Job Name: The Old Power Station Vastern Road
Job No: 47500
Note No: TN004
Date: 9th June 2020
Prepared By: Joe House / Dan Townsend
Subject: RBC Highway Response

This technical note has been prepared by Stantec on behalf of Berkeley Homes (Oxford and Chiltern) Ltd to provide a response to Reading Borough Council (RBC) highway comments provided in the letter dated 28th May 2020.

The comments provided are in response to the full planning application (ref. 200188) for the demolition of existing structures and erection of a series of buildings ranging in height from 1 to 11 storeys, including residential dwellings (C3 use class) and retail floorspace (A3 use class), together with a new north-south pedestrian link, connecting Christchurch Bridge to Vastern Road.

THE OLD POWER STATION
VASTERN ROAD, READING
SITE ACCESS PASSING PLACES
REFUSE SWEEP PATH ASSESSMENT

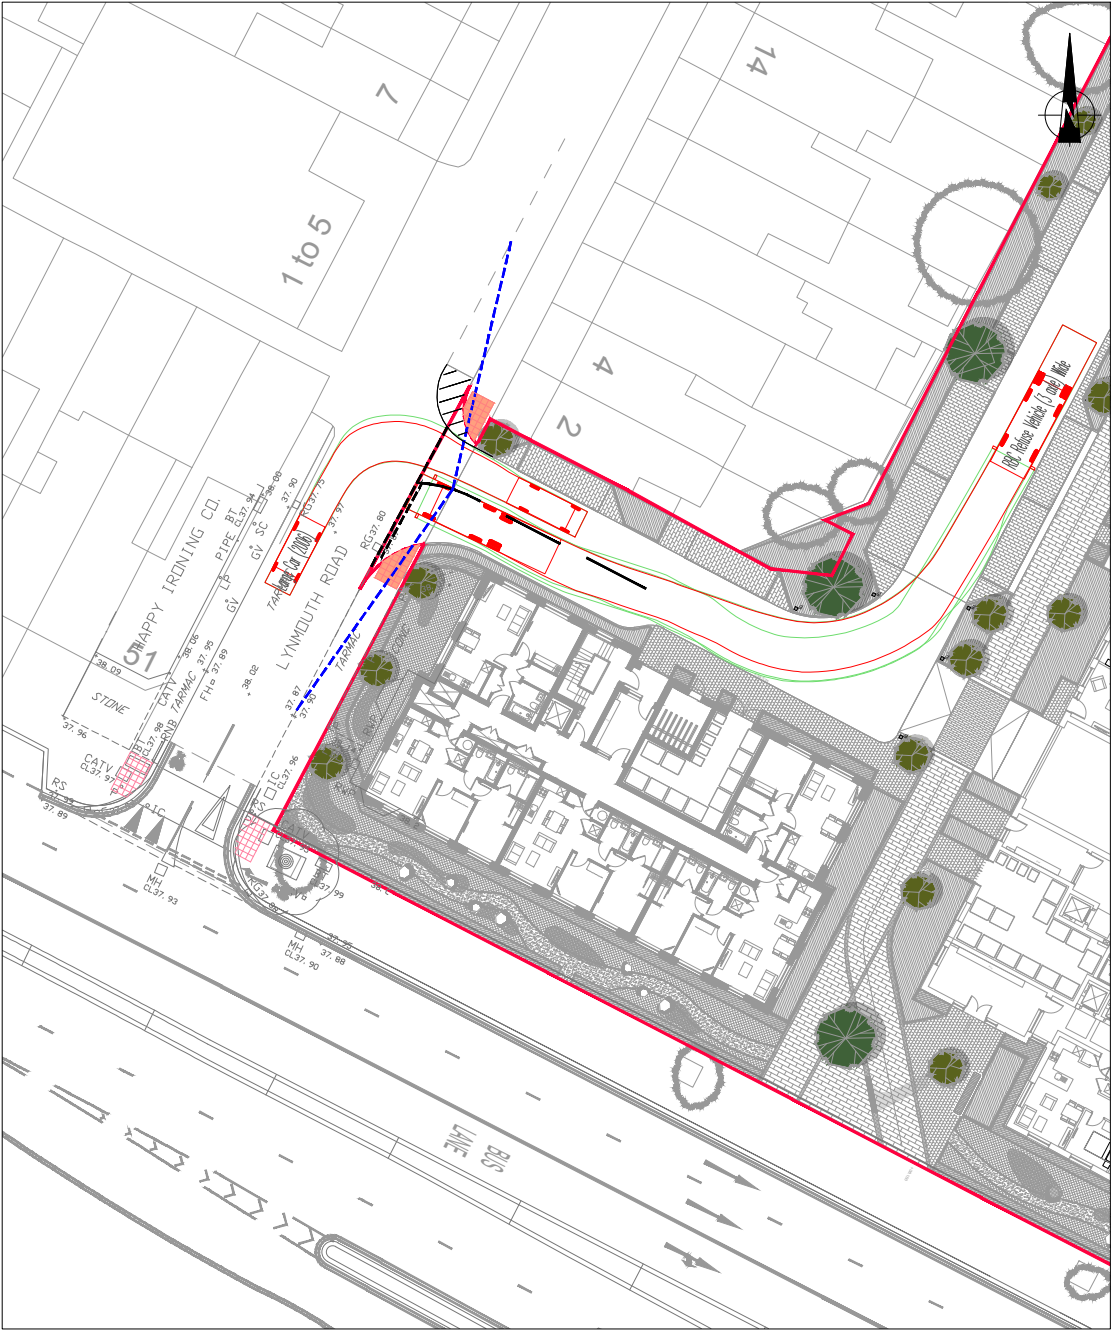
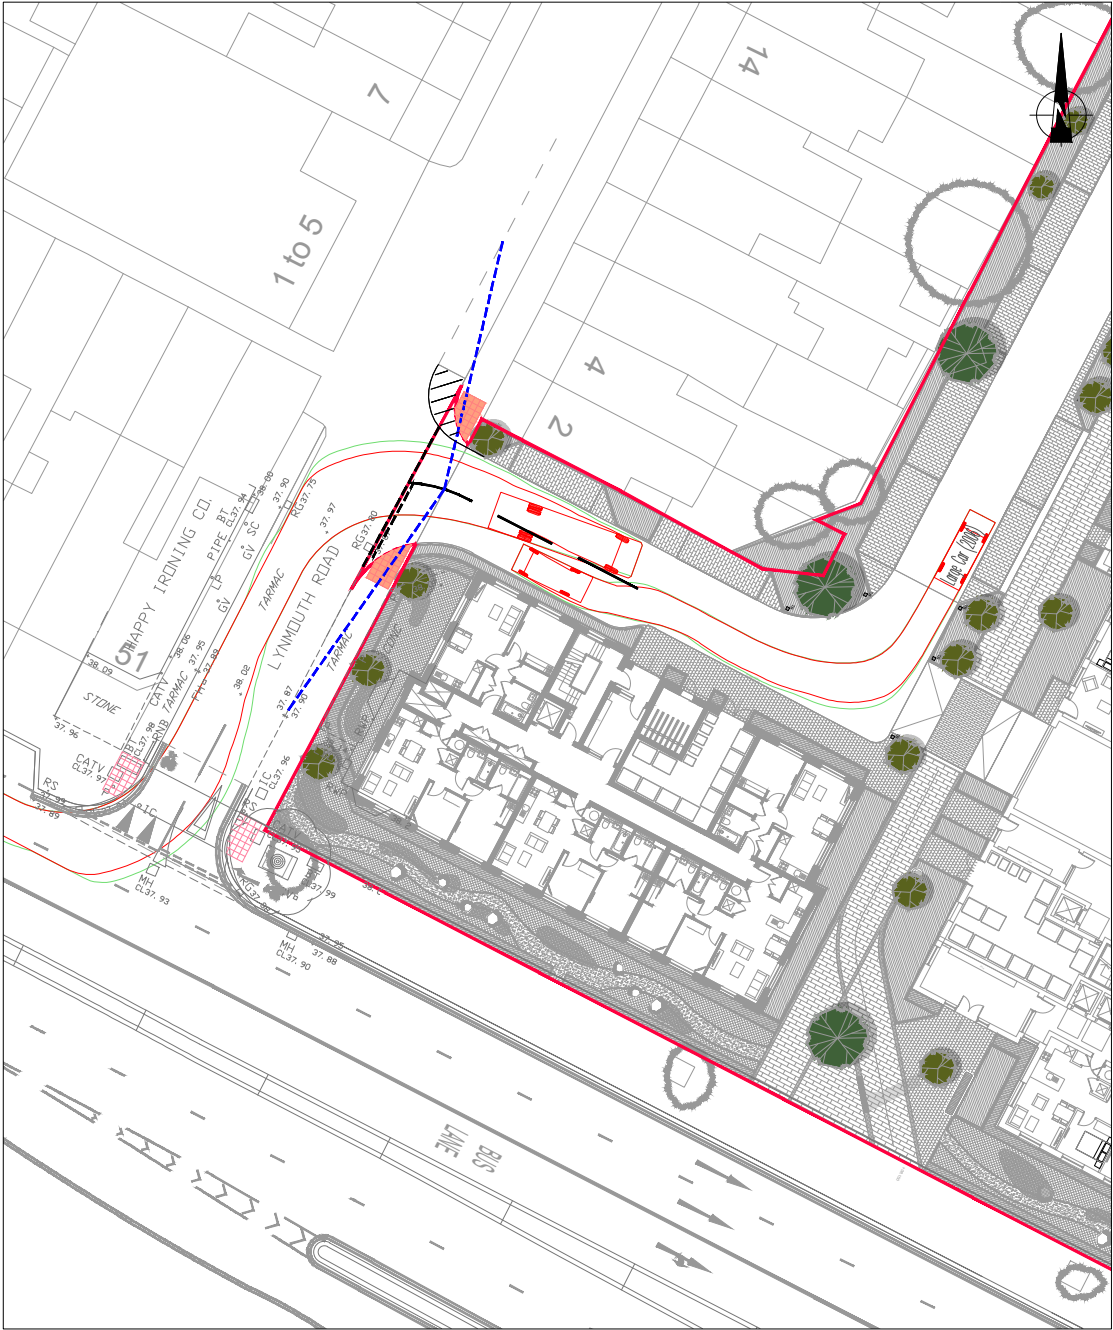
- a) *“Tracking diagrams have been provided that identify that two cars can pass one another however it is noted that the tracking for a refuse vehicle and a HGV would require the use of the full width of the carriageway not only through the site but also on Lynmouth Road. This is for a distance in excess of 50m whilst also negotiating two 90 degree bends, this will therefore result in conflict between cars and service vehicles as well as vehicles with pedestrians and cyclists using the north – south footway / cycleway. The proposed scheme therefore does not accord with DfT document Manual for Streets...”*

“The road widths on the bends should therefore be altered to ensure a continued vehicle flow through the site can be provided”

As shown in the swept path assessment drawings **47500/5500/002** to **004** the site access is able to accommodate large refuse and HGV access whilst also providing a suitable place once within the site. This has been checked for both direction of access meaning that a HGV or Large Refuse vehicle entering the site and a car negotiating the internal bend exiting have an opportunity to pass prior to the site access. The reverse scenario has also been tested so that a large vehicle leaving the site is capable of passing a car entering the site.

Drawing Issue Status					
FOR INFORMATION					
THE OLD POWER STATION VASTERN ROAD, READING INTERNAL PASSING PLACES SWEEP PATH ANALYSIS					
Client					
Berkeley Designed for life					
Date of 1st Issue 10.06.20		Designed -		Drawn JH	
A2 Scale 1:250		Checked DT		Approved DT

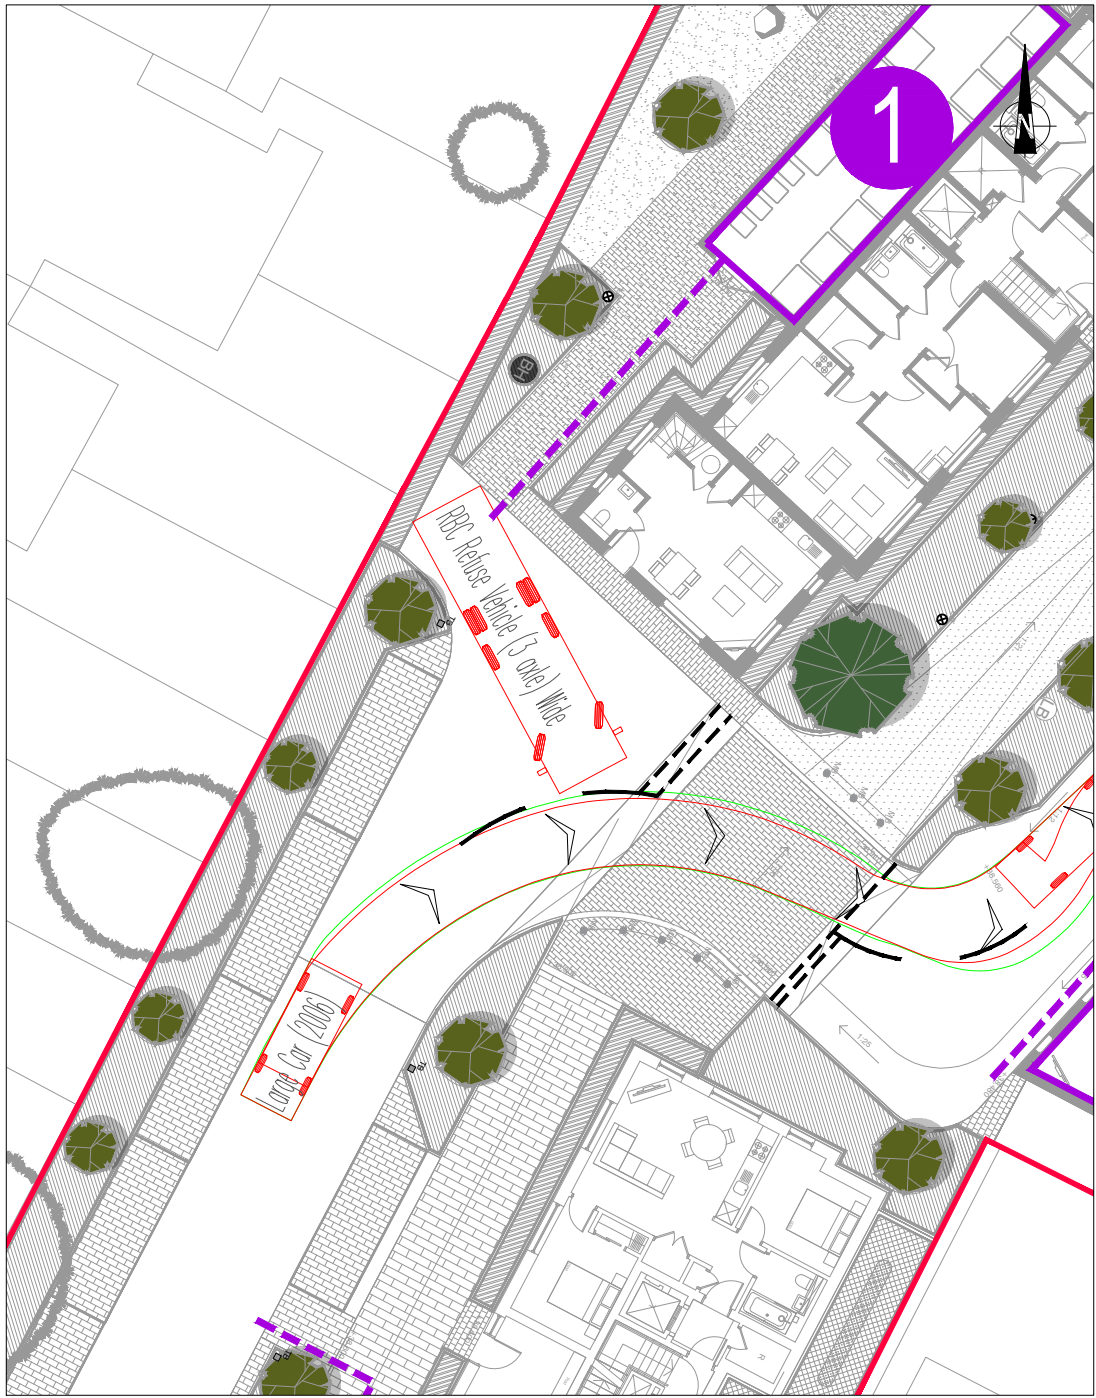
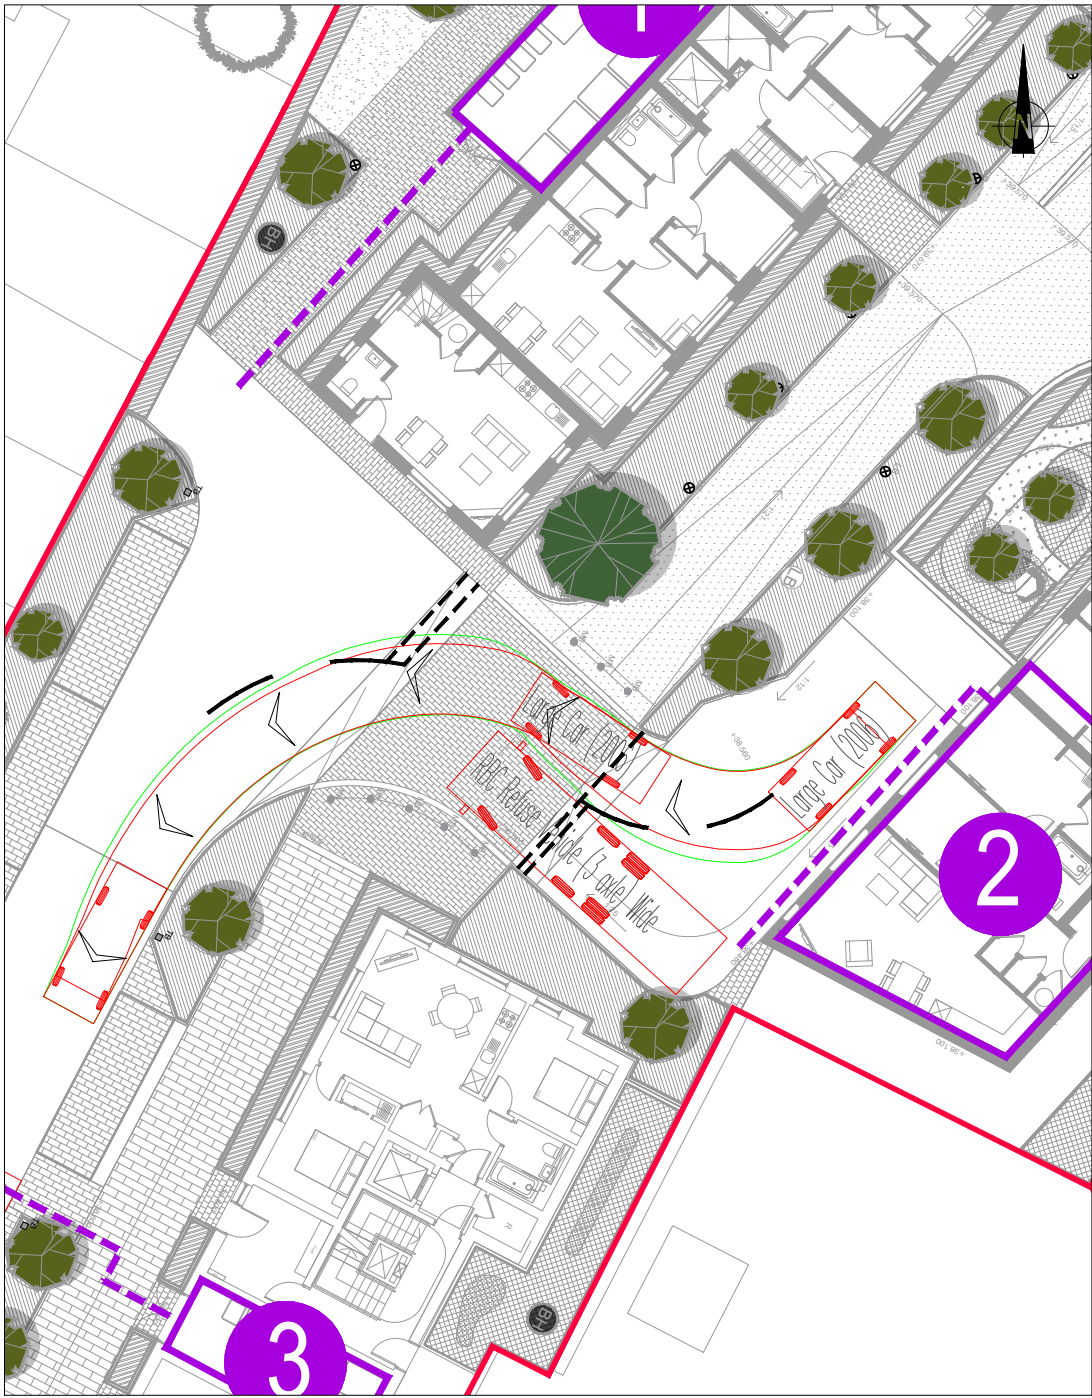
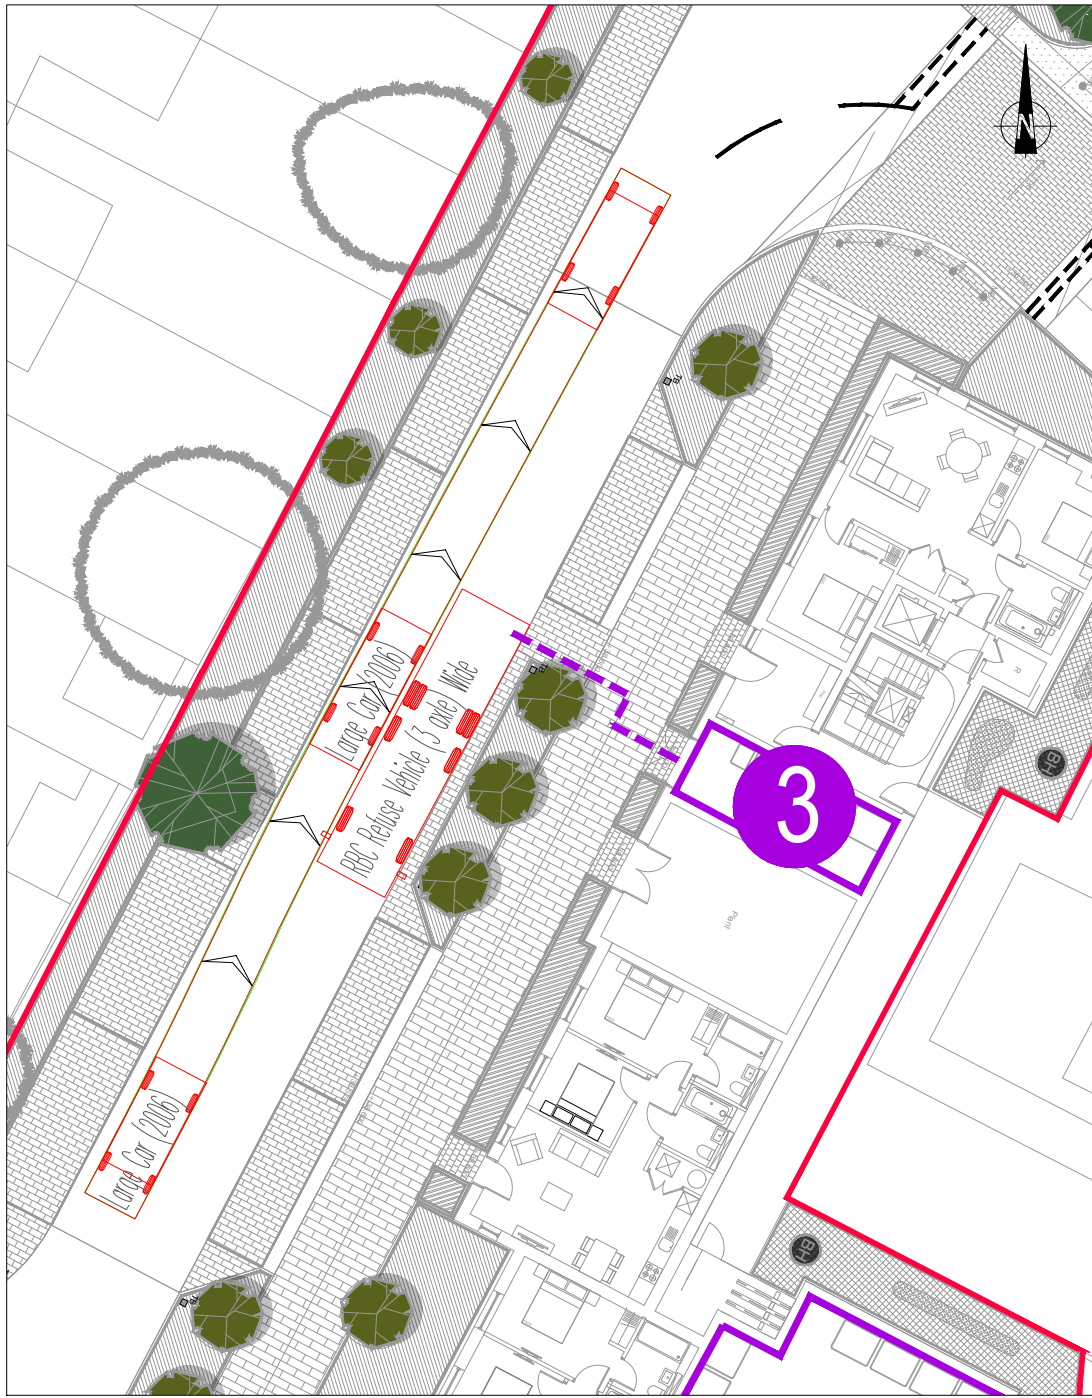
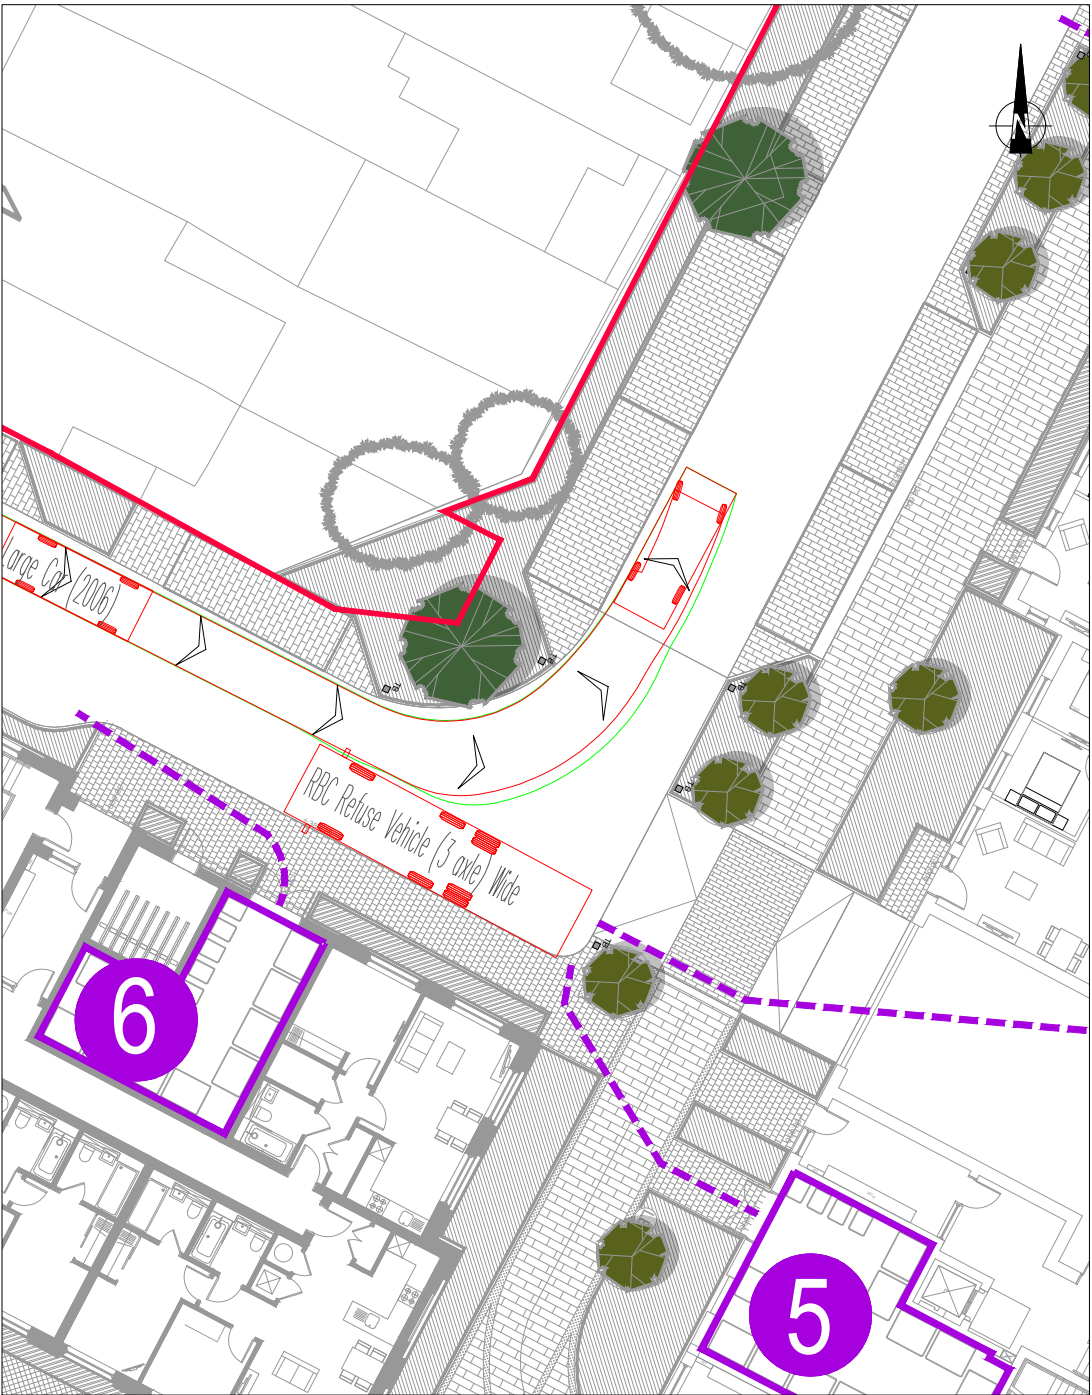
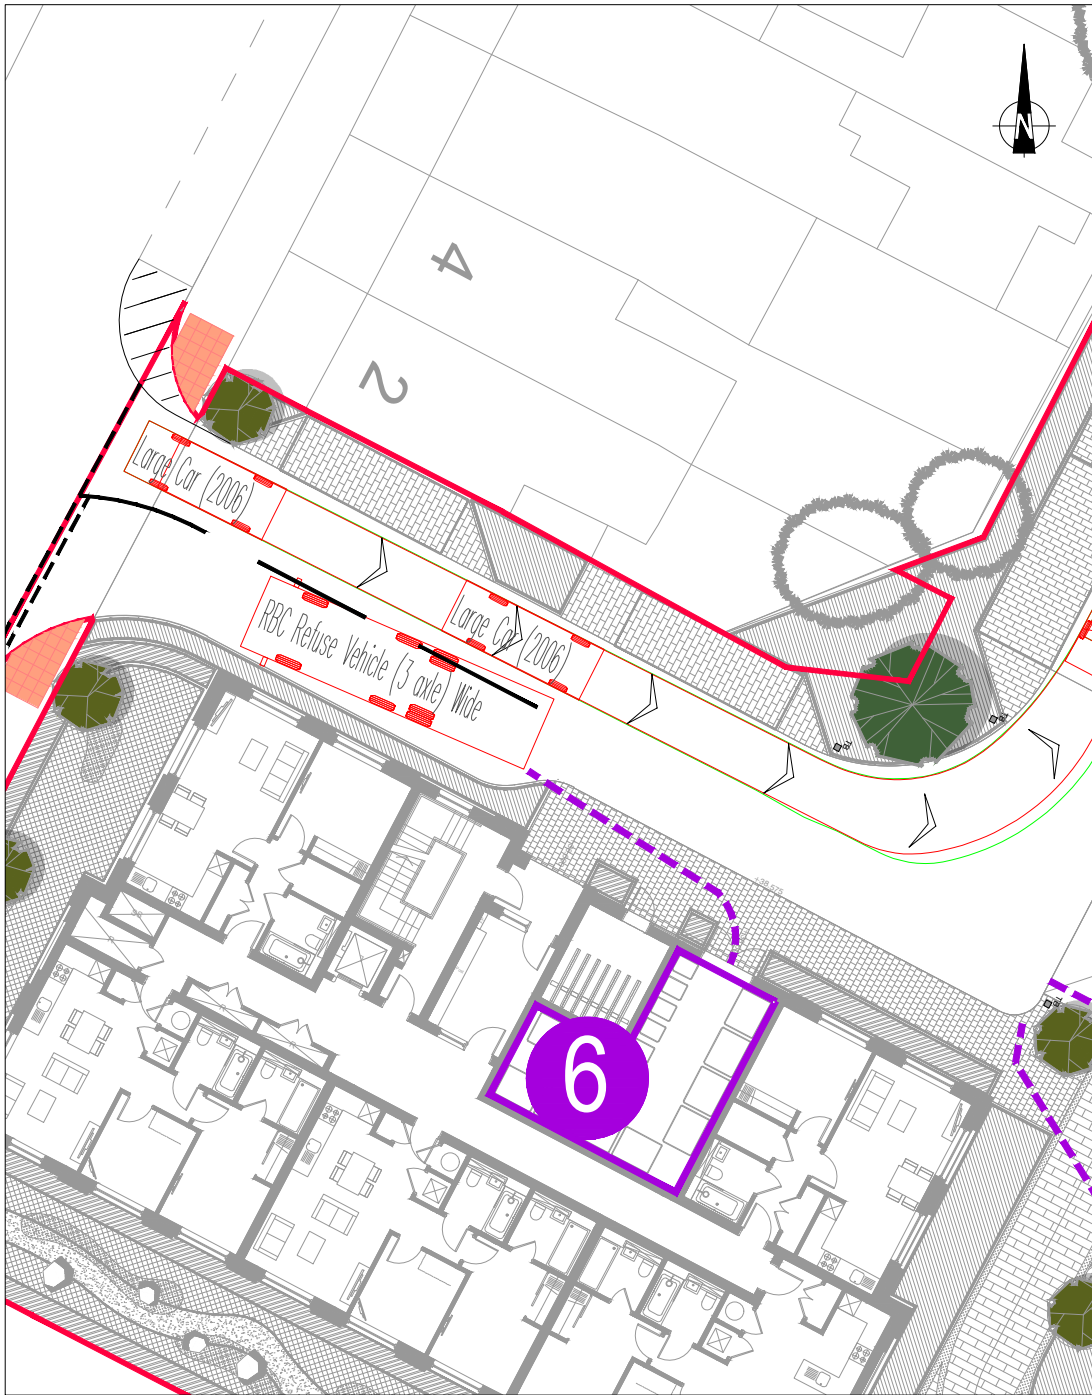
- b) *"In addition the turning head at the northern end of the site requires refuse and delivery vehicles to drive and reverse over the dedicated footway / cycleway. As stipulated at the pre-application stage I have concern over this movement given the importance of this pedestrian / cycle route and the potential for conflict with service vehicles. A revised turning head is therefore required that does not result in reversing over this route."*
- c) *"It was also requested that it would need to be clarified where any servicing will take place so as to not obstruct access to the basement car park, the turning head or the footway / cycleway..."*

Refuse collection will be weekly and deliveries by HGVs will be infrequent. The turning circles associated with the larger vehicles and the constrained width of the site at this location means these vehicles will need reverse over the foot/cycleway when turning at the northern end of the site. At the time when these vehicles are servicing the site, suitable passing places are available, and access is retained to the car parking areas. The passing places within the site whilst servicing is being carried out are illustrated on drawing **47500/5500/006**
